2) Change on Motor from S/N 30,058E.

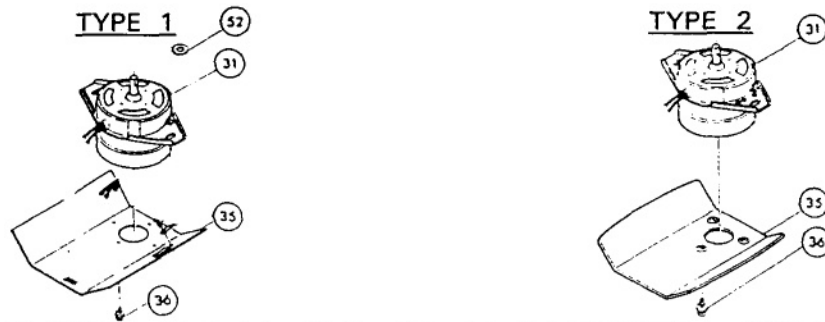
FIG.	DESCRIPTION	TYPE 1	TYPE 2
31	Motor	PART# 629510-4 (Discontinued)	PART# 629644-3
35	Under Cover	PART# 342516-2 (Discontinued)	PART# 344030-4
36	Screw	PART# 911104-2 M4x6 (Use 4 ea.)	PART# 911108-4 M4x8 (Use 3 ea.)
52	Washer	PART# 267040-3 (Discontinued)	-----

The above parts are interchangeable as a set.
